# **PARKERS RIDGE**

## STORMWATER MANAGEMENT CALCULATIONS

2<sup>nd</sup> Submittal: 6/1/2023

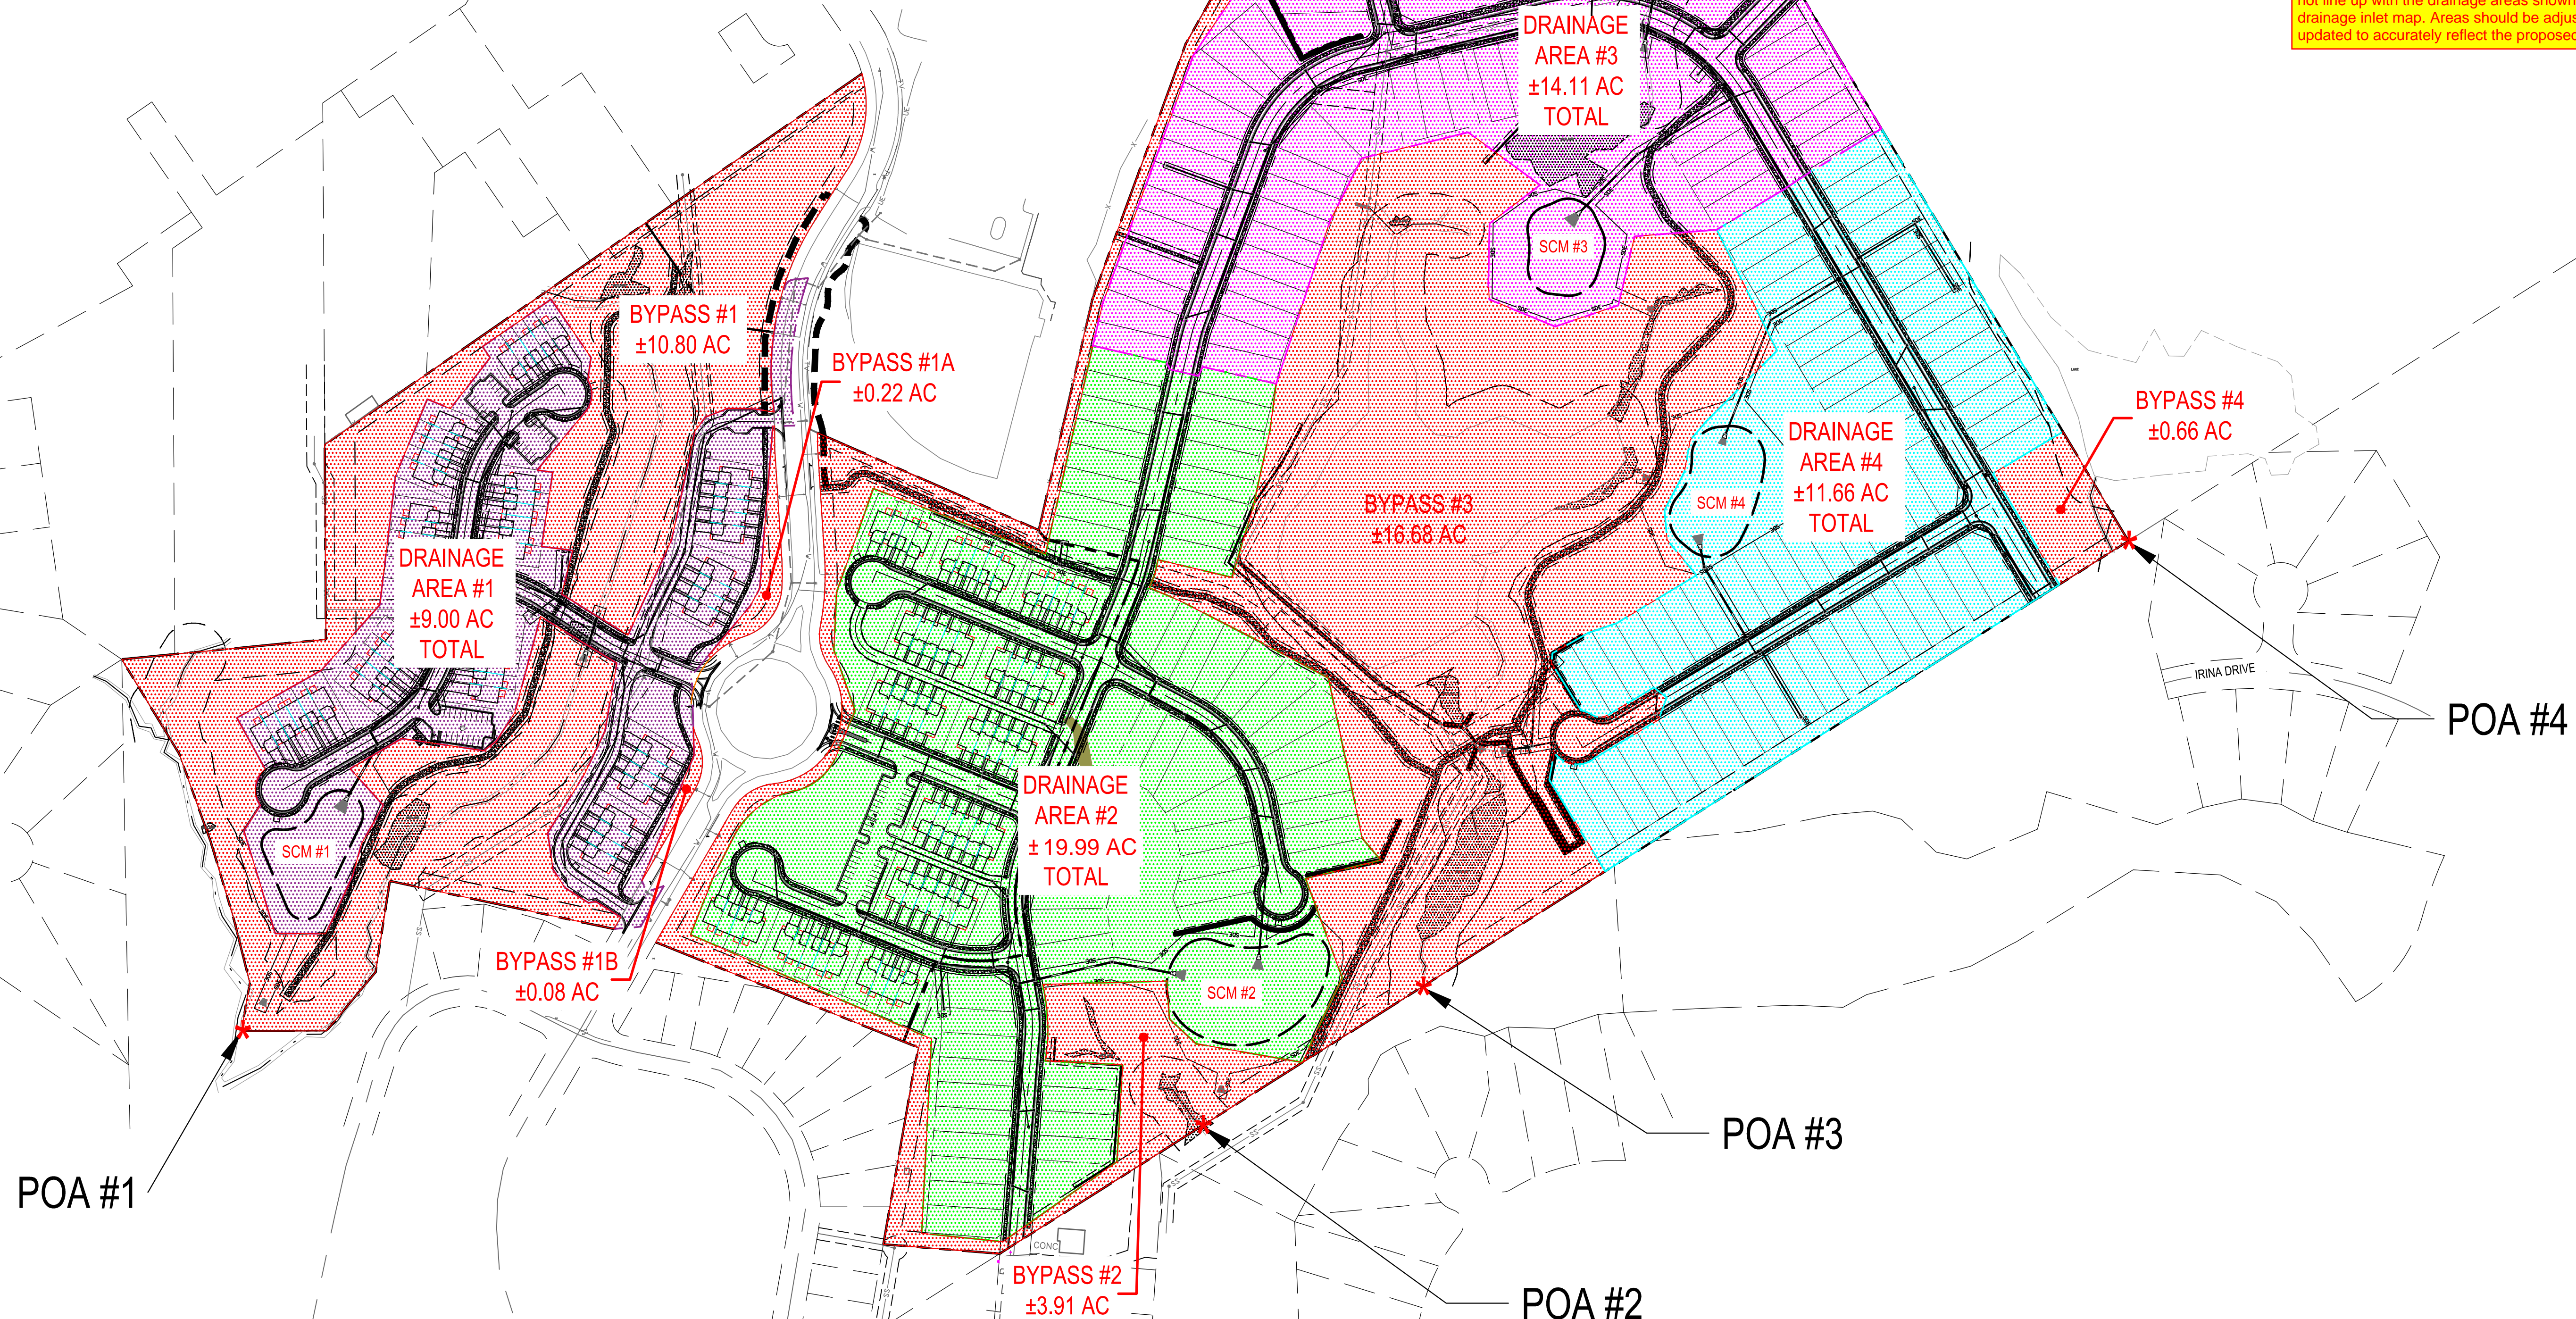
#187- Any changes to pre-development drainage areas should be reflected in the post-development map.

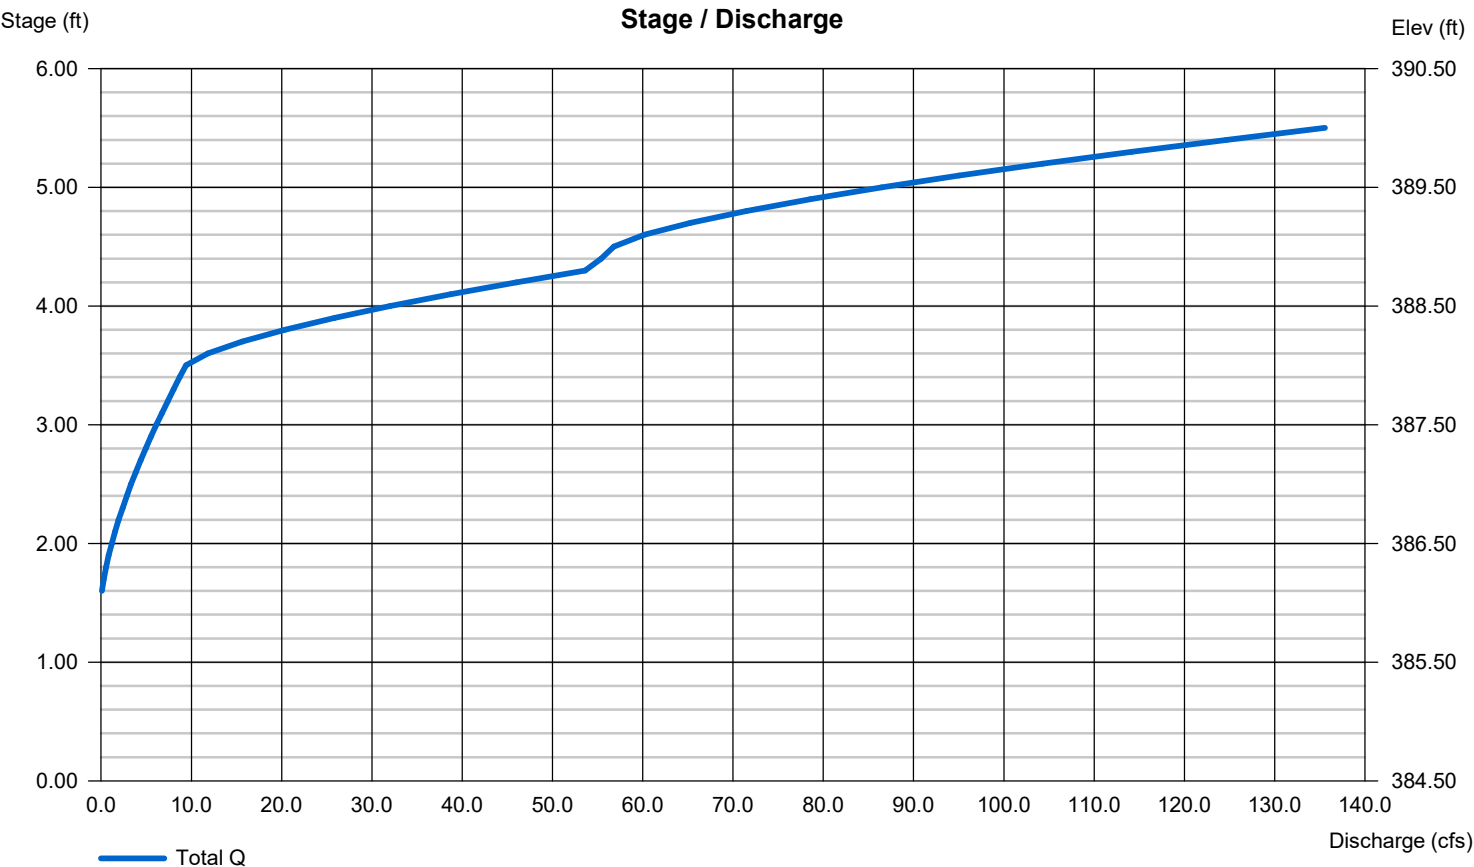
#196- verify this matches what is shown on the detail sheet

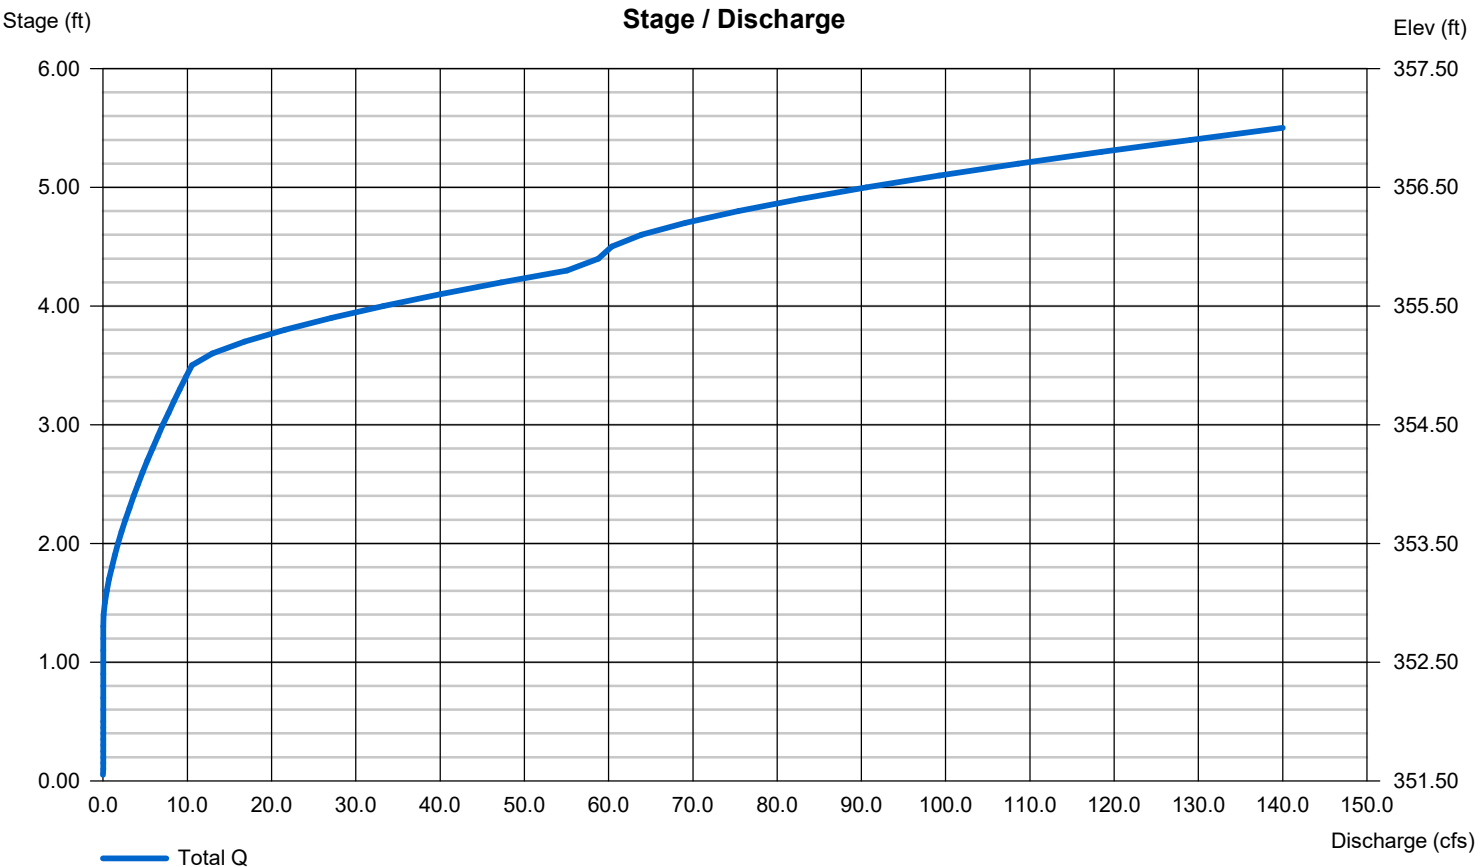
#196- verify this matches what is shown on the detail sheet

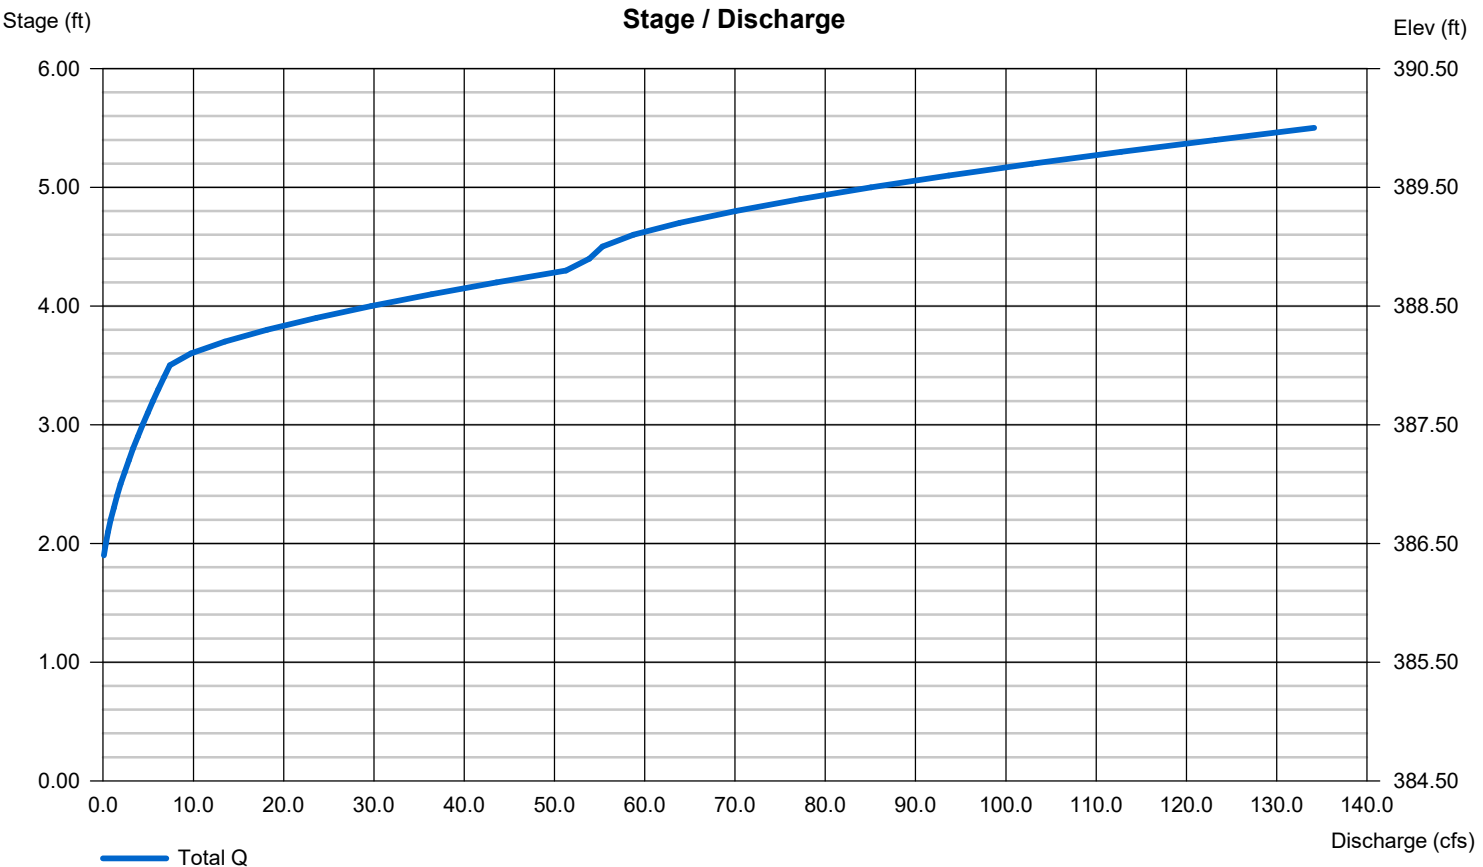
#196- verify this matches what is shown on the detail sheet

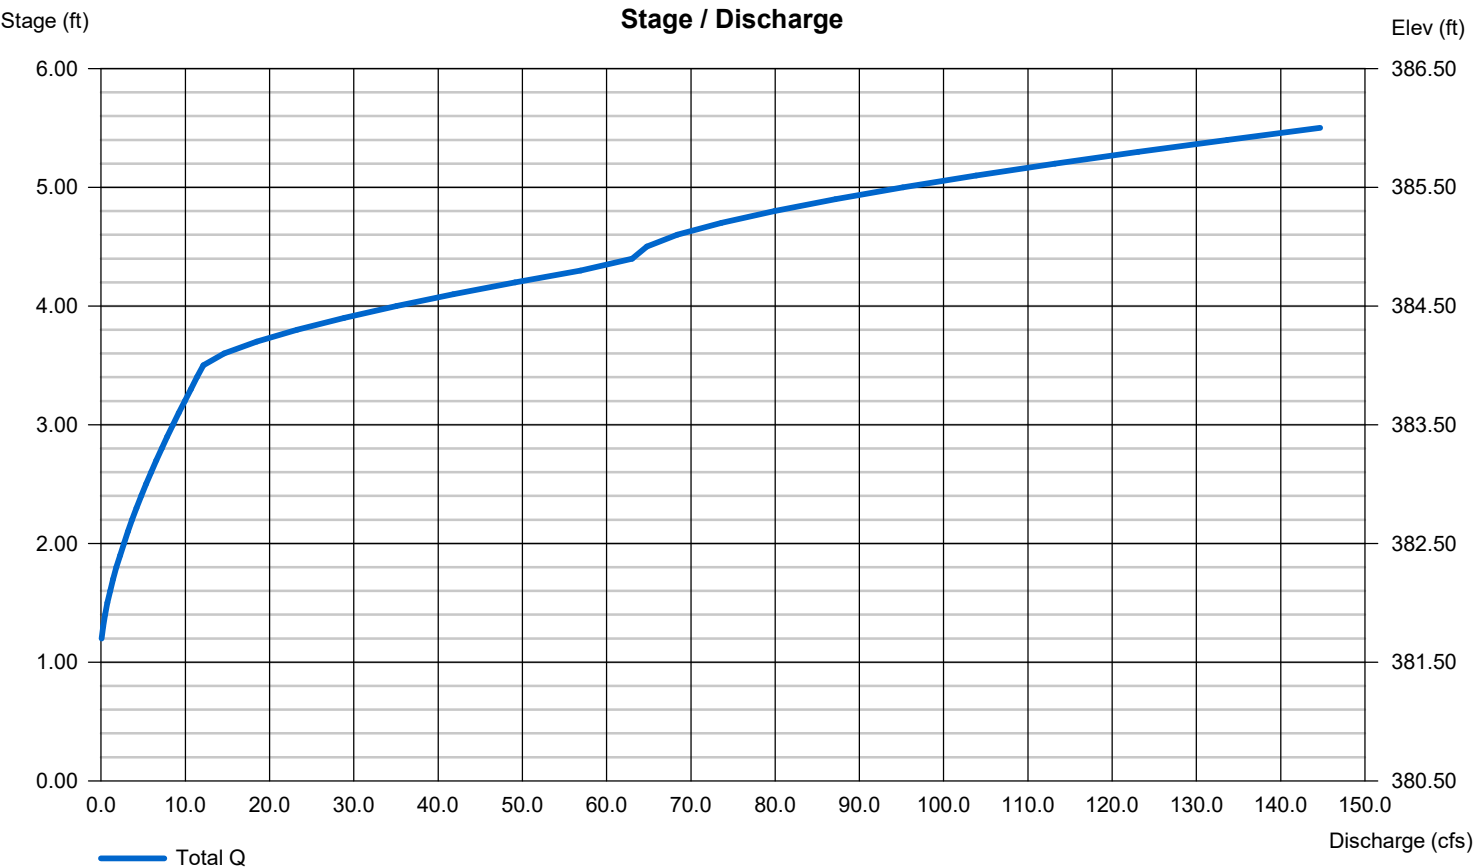
#196- verify this matches what is shown on the detail sheet
